PLAN-026852

Proposal: Single storey side extension linking detached garage to existing house including conversion of existing garage to habitable use and rear extension within the setting of a listed building.

Site: Hazel Cottage, Church Lane, Yapton, BN18 0EH.

Y/8/19/HH

Due to surface water inundation issues in the Lidsey Catchment "The applicant is advised to adopt, where appropriate, the measures in the table "Practical measures to reduce the potential impacts of development".

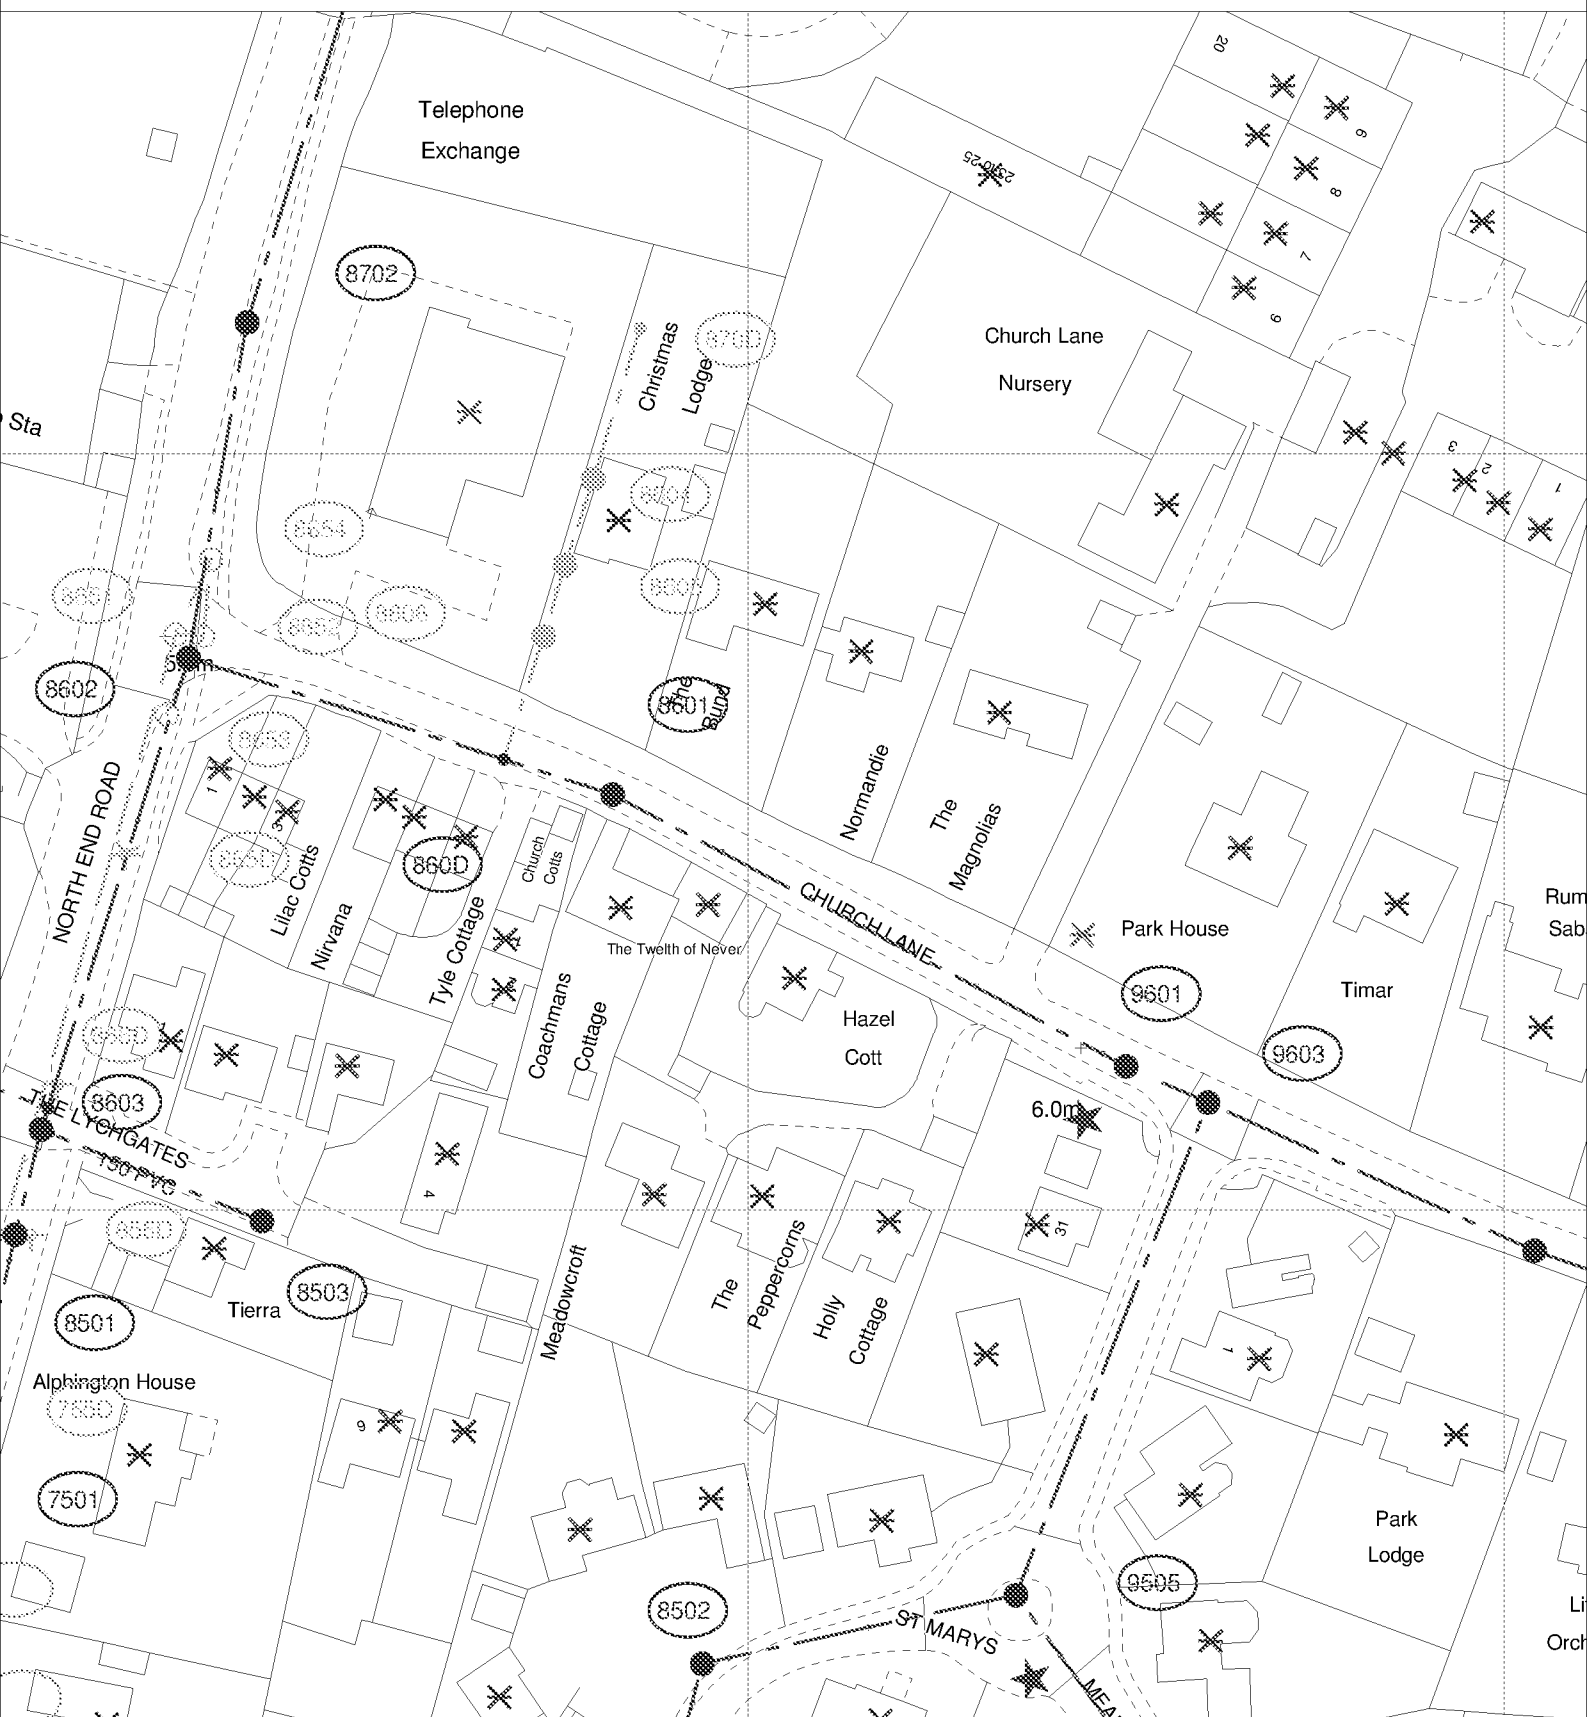
Developer should look to protect the public sewerage system from inundation and infiltration, which contribute to flooding in unfavourable conditions.
